WECC 10-Year Regional Transmission Plan

Summary of Proposed Changes

Page 29, Insert new figure (from the 2019 Study Report):

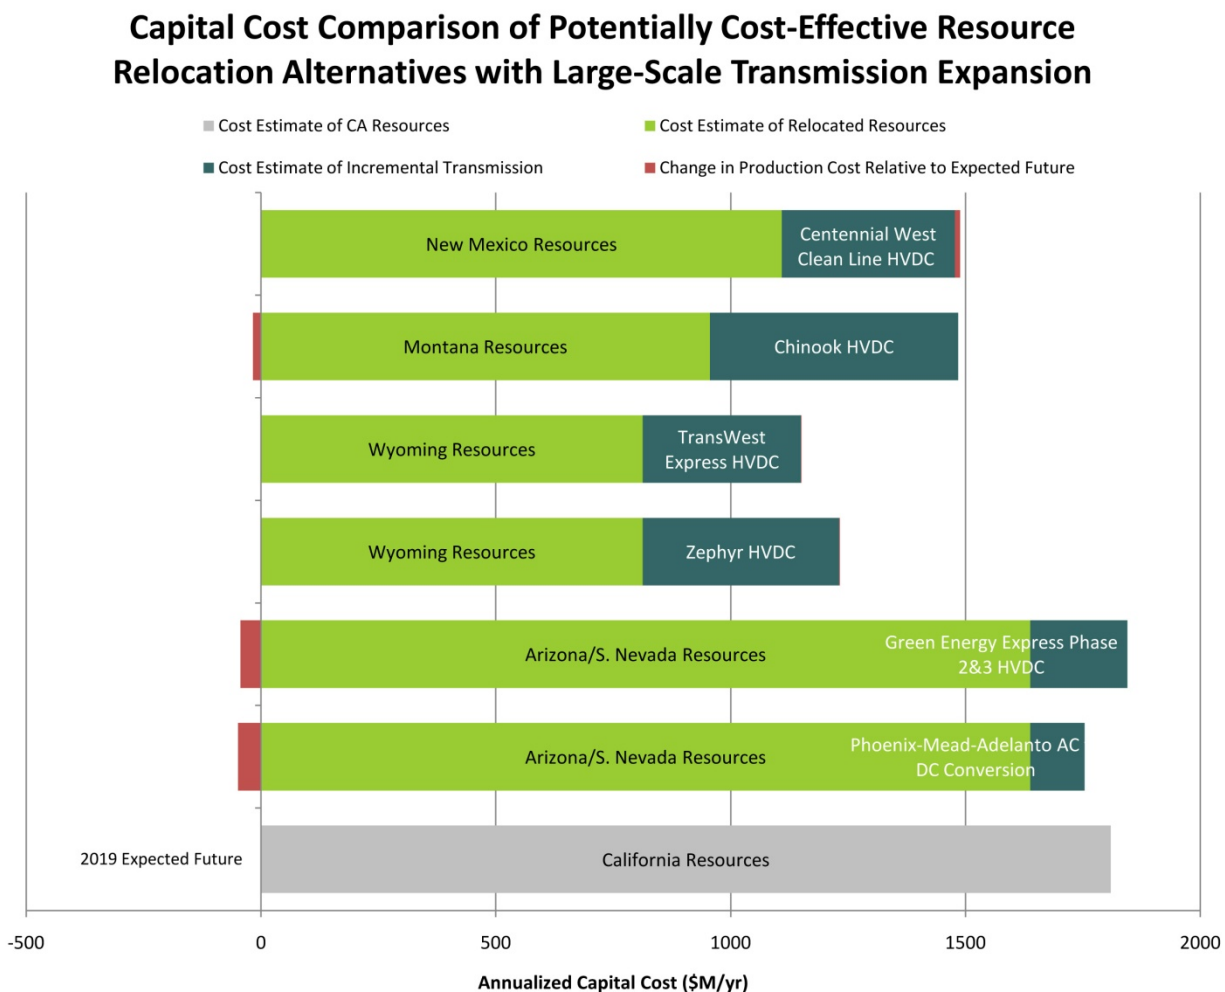
Propose the following inclusions with the graphic above: Add footnote to the title of the graphic indicating that the capital costs are assumed to be net of applicable tax incentives and tax credits.
